# Addendum to Flood Risk Assessment

Land South of Kings Head PH, Lower Horsebridge, Hailsham BN27 4DH

**Abtec Limited**  
c/o Decimus Ltd  
1 Lonsdale Gardens  
Tunbridge Wells  
Kent TN1 1NU  
**Ref:** 10273  
**Date:** January 2021

PO1	INITIAL ISSUE	08.01.21	PH	MR
Rev	Amendments	Date	Dsn	Chk
Status	PRELIMINARY			
Client	DECIMUS			
Architect	ON ARCHITECTURE			
Project	LAND AT LOWER HORSEBRIDGE HAILSHAM			
Title	EXISTING AND PROPOSED FLOOD VOLUMES			
Date	JANUARY 2021	Scale @ A1	AS SHOWN	
Clients Ref	Project Ref. 10273			
 Gloucester House, 66a Church Walk, Burgess Hill, West Sussex, RH15 9AS Tel: 01444 871444 Web: www.gtacivils.co.uk				
Drawing Number	10273/1103	Rev.	P01

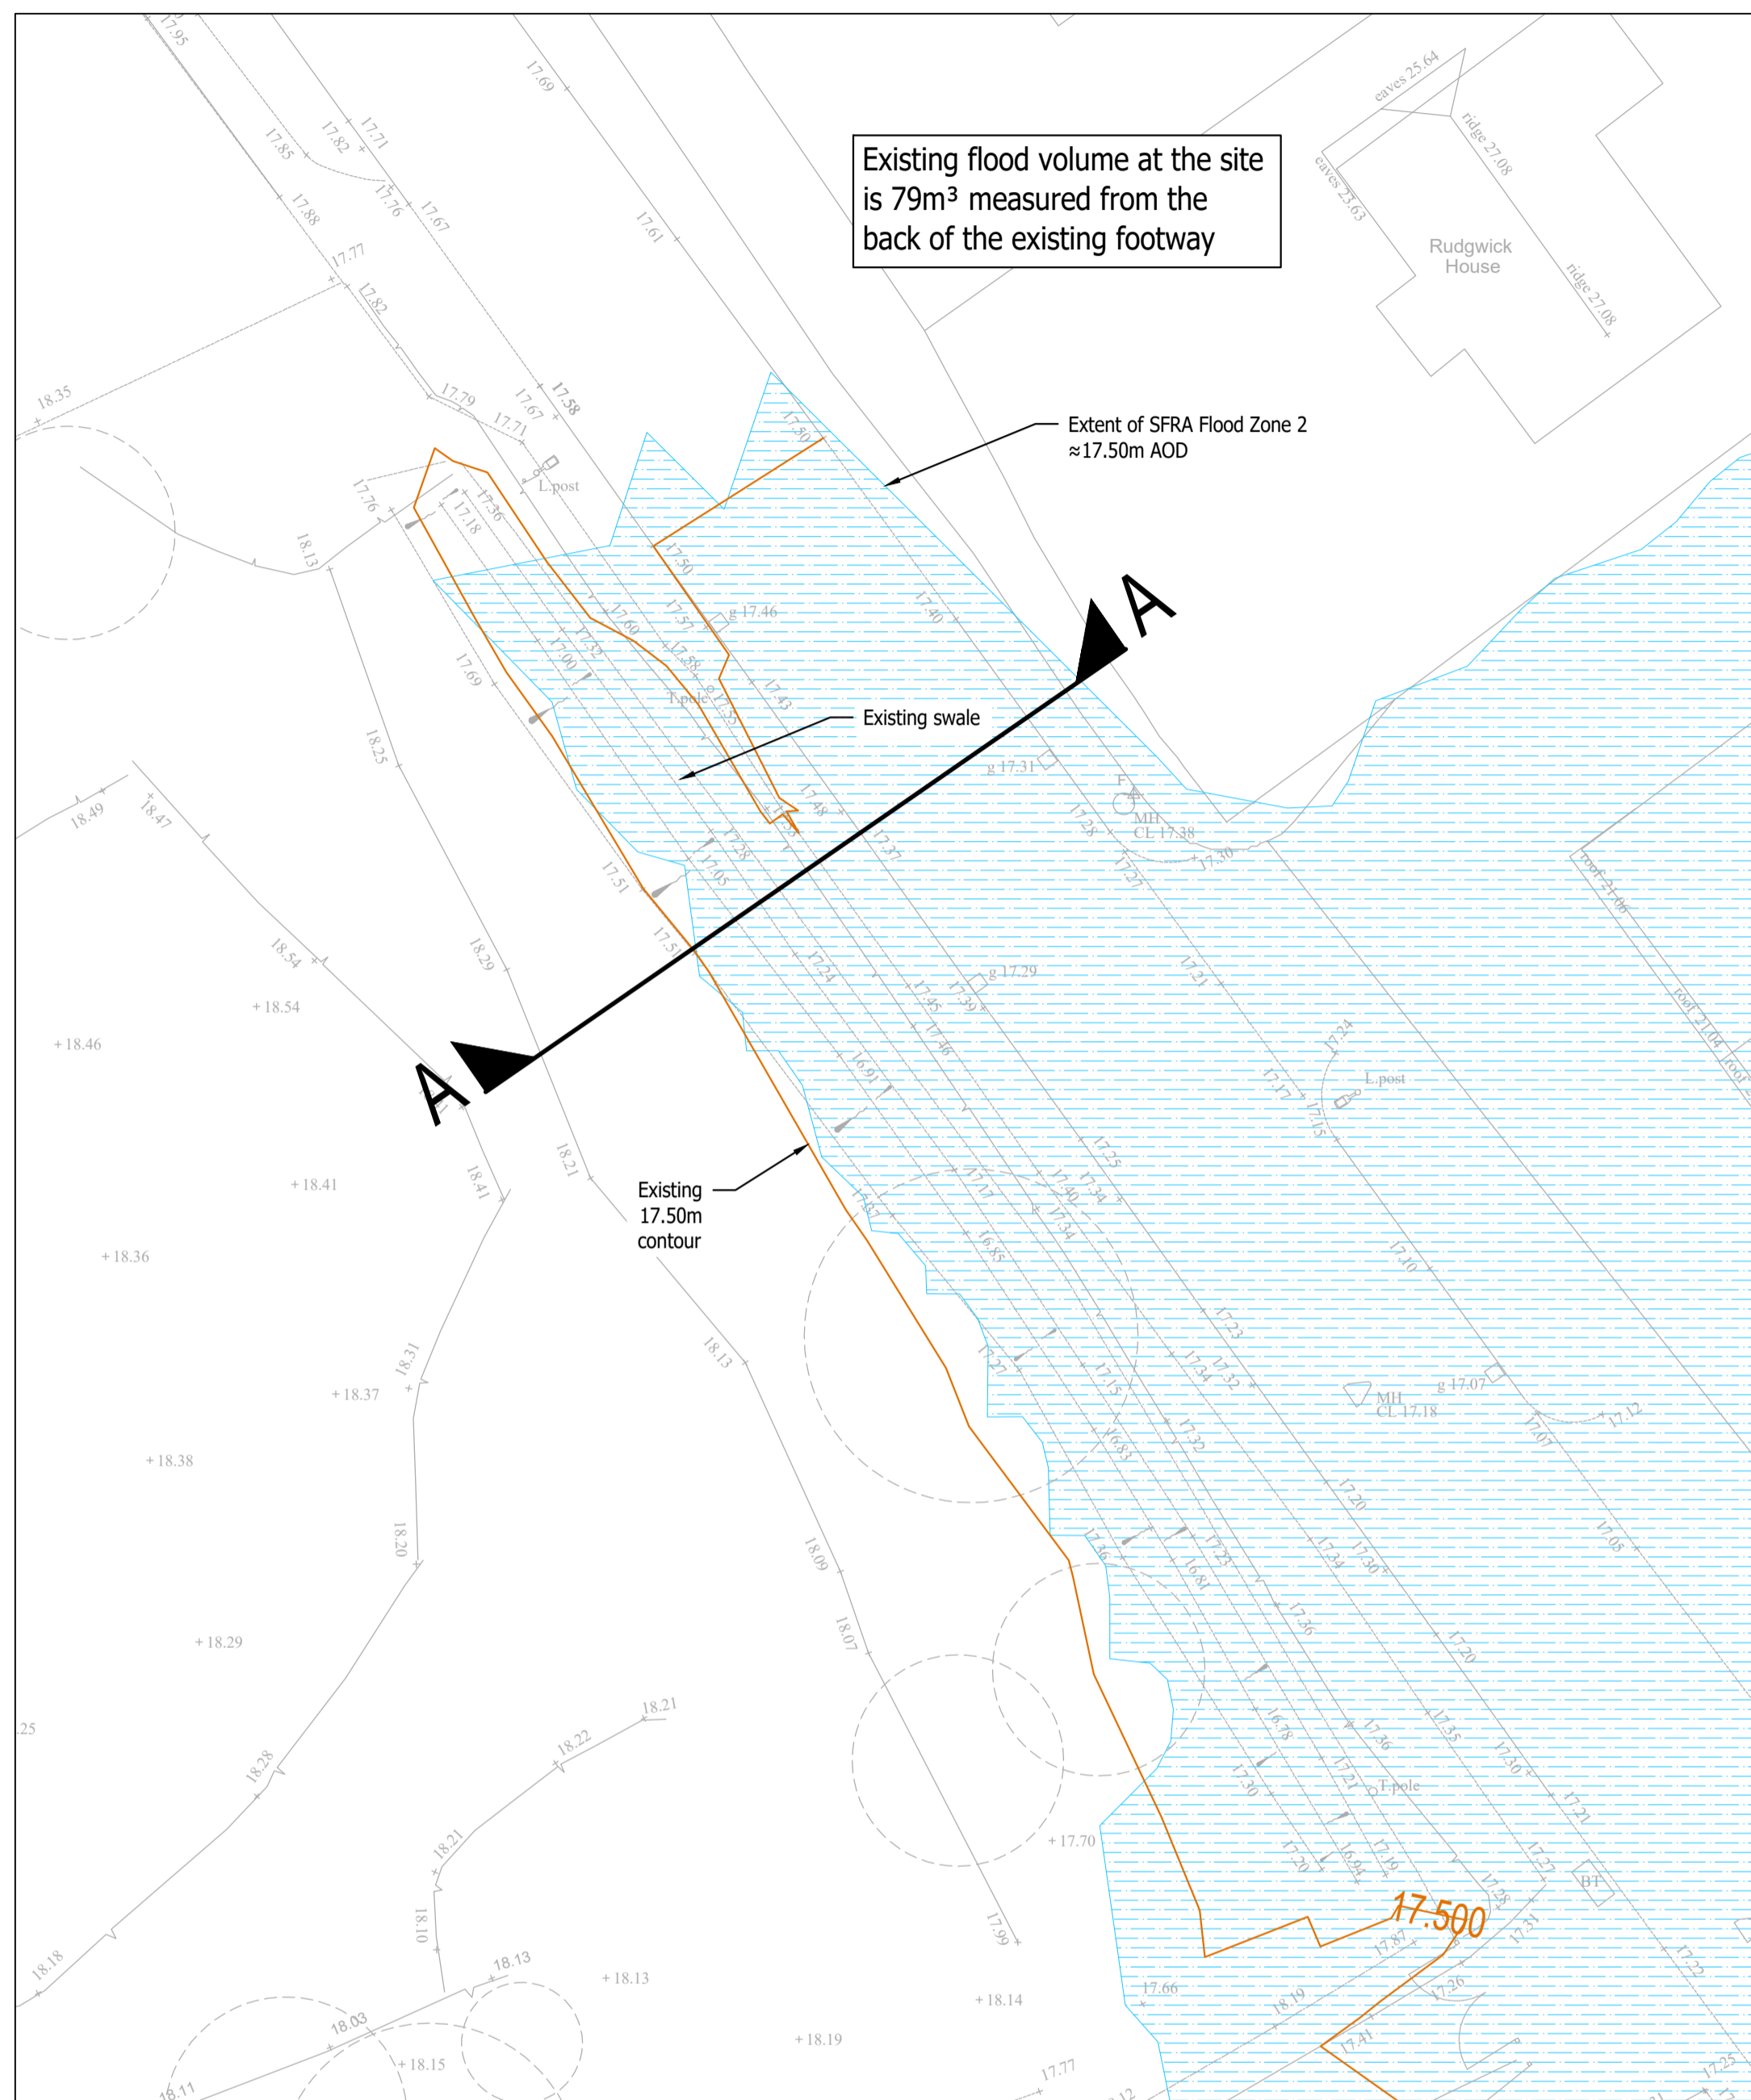
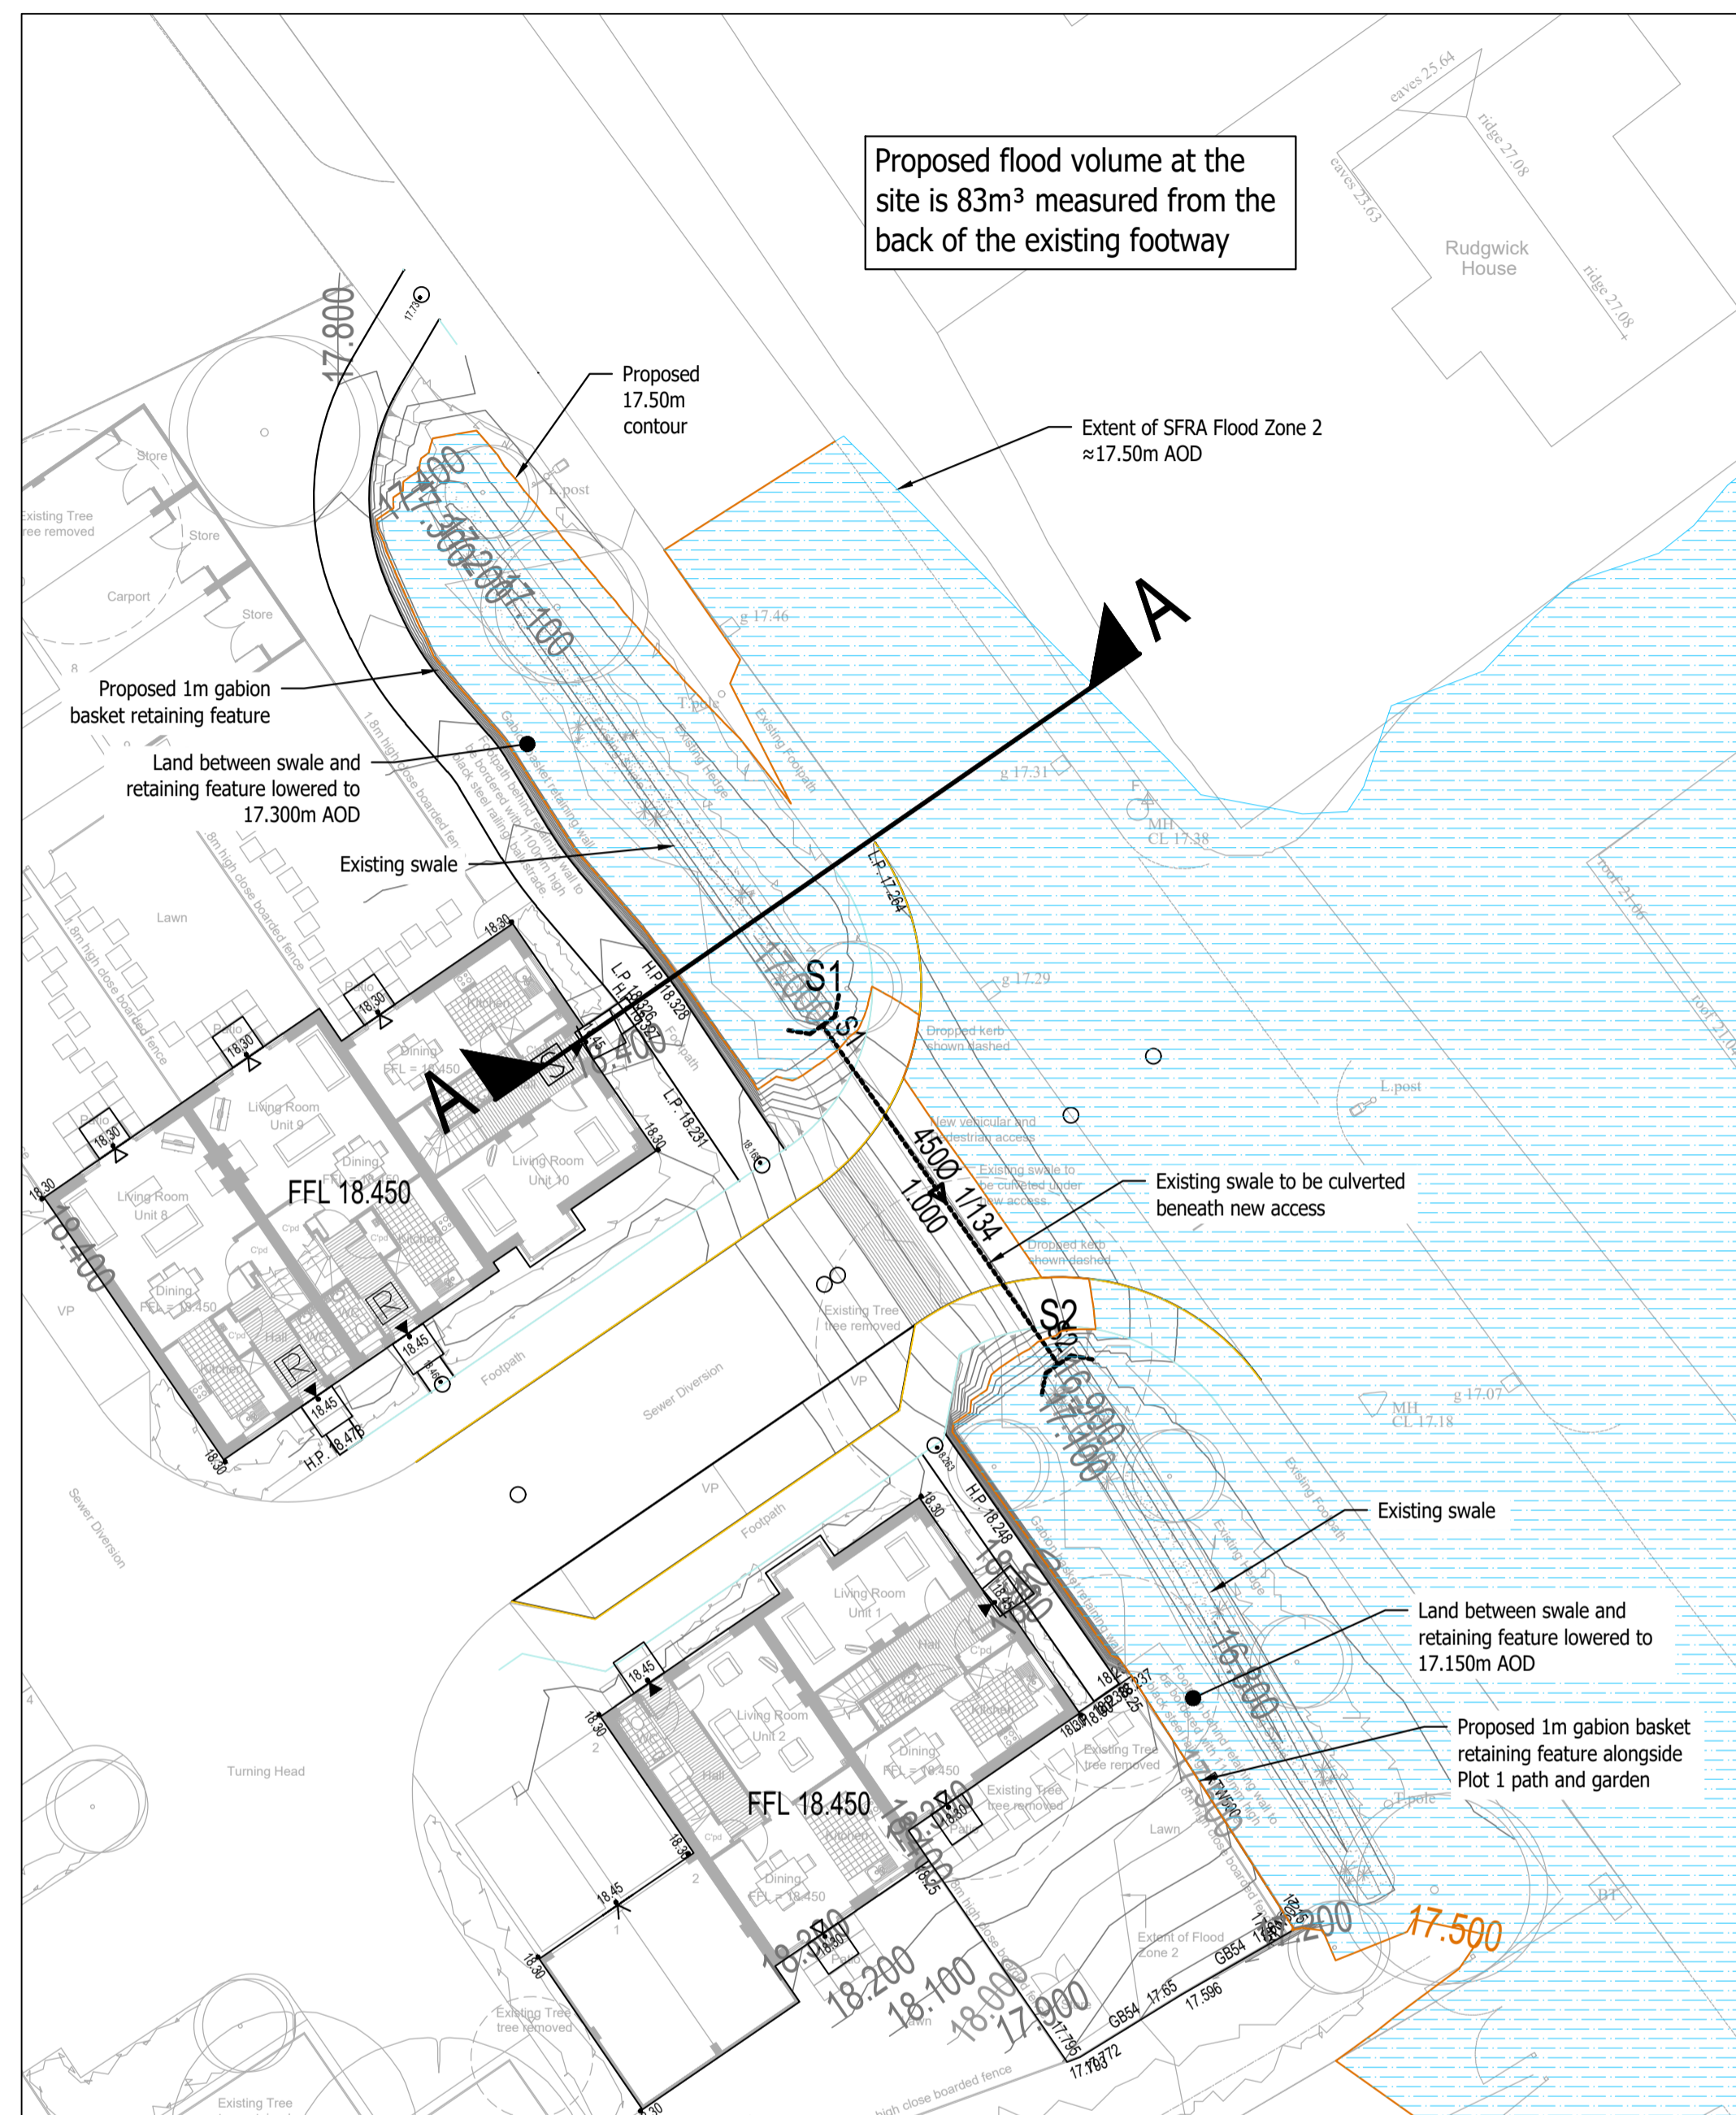
A flood level of 17.5m AOD would affect the A271 and the eastern boundary of the site, but not the development plots. Proposed FFLs are set to 18.45m AOD. The minor impacts at the eastern boundary are dealt with as follows:

- The proposed footpath alignments at the eastern boundary have been moved slightly west to keep clear of the flood outline. Dry access / egress will thus remain available during an extreme flood event.

- The rear garden of Plot 1 has been adjusted to stay clear of the flood outline excepting a strip of land at the south-east corner. The back garden is to be raised above the flood level to remain safe during an extreme flood event.

The new access road needs to be ramped into the site at 1:12 to meet proposed levels. The new junction construction and the Plot 1 garden raising would result in a modest loss of floodplain volume. This has been assessed using 3D modelling software.

Measured from the back of the existing footway, a flood level of 17.5m AOD would result in a flood volume at the site of 79m<sup>3</sup> in the existing undeveloped scenario.

The impact of the access road and garden raising will be compensated by lowering the strip of land between the existing swale and the new footpaths by around 0.2m. This is illustrated on the appended plan. A flood level of 17.5m AOD in the developed scenario would result in a flood volume of 83m<sup>3</sup>. This is an additional 4m<sup>3</sup> of capacity and represents a modest betterment locally in terms of flood risk.

1. SFRA FLOOD ZONE 2 OUTLINE PROVIDED IN PDF FORMAT BY WEALDEN DC. FLOOD LEVEL INTERPRETED AS 17.5m AOD BASED ON COMPARISON WITH SITE SURVEY DATA.
2. FLOOD VOLUMES CALCULATED USING SITE3D SOFTWARE.
